SERVICE BULLETIN

TS-S41

Safety Recall / NHTSA Campaign # 13V - 317

DANA Axle Shaft Replacement

Air Disc Brake Axle Exploded View

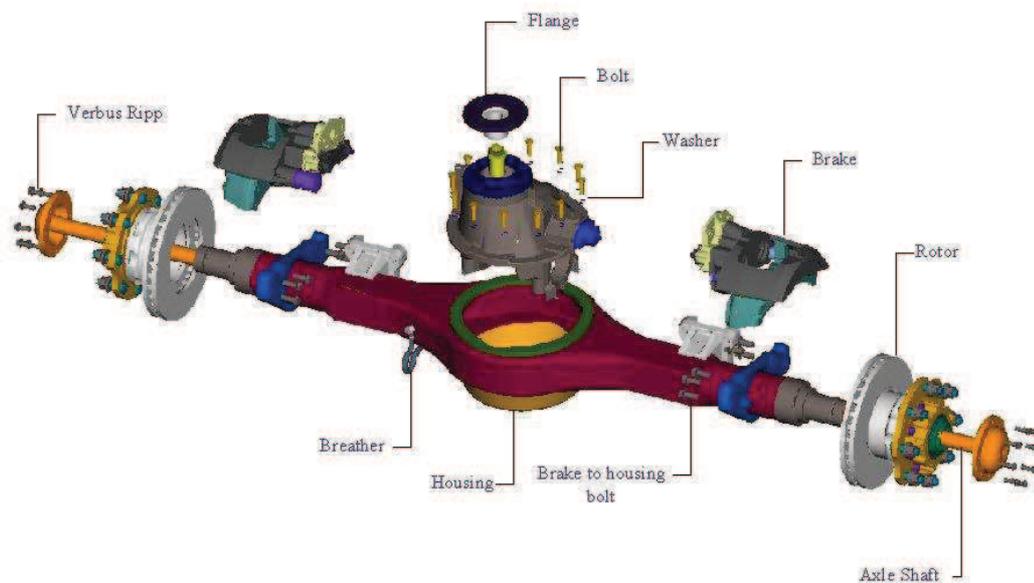
This bulletin is purposed to prevent DANA axle shaft failure in TS30 buses.

SUBJECT: Axle Shaft Replacement

- **Background:** A request was received for Dana to issue a service instruction.
- **Scope of bulletin:** This bulletin describes the procedure to remove and replace the axle shafts.
- **Procedure:**

1. Remove the 8 x **M16 Verbus Ripp** retaining bolts which are securing the axle shaft to the hub.
2. Place a drip tray under the flange end of the axle shaft to catch any oil which may be lost as the axle shaft is extracted.

3. Insert 2 x **M10 x 1.5** 'jacking bolts' into the 2 threaded holes in the axle shaft flange. This will pull the axle shaft flange away from the hub face.

4. Pull the axle shaft from the axle.
5. Clean the face of the hub and apply a thin bead of soft sealant (**Loctite 518** or similar).
6. Insert the new axle shaft into the axle aligning the axle shaft splines with the differential side gear splines. Some rotation of the axle shaft will be necessary to align the splines.

7. Fit the 8 x **M16 Verbus Ripp** axle shaft retaining bolts and tighten to the correct specified torque of **314 - 346Nm (232 lb.ft - 255 lb.ft)**
8. When both axle shafts have been replaced check and top up the axle oil level if necessary.
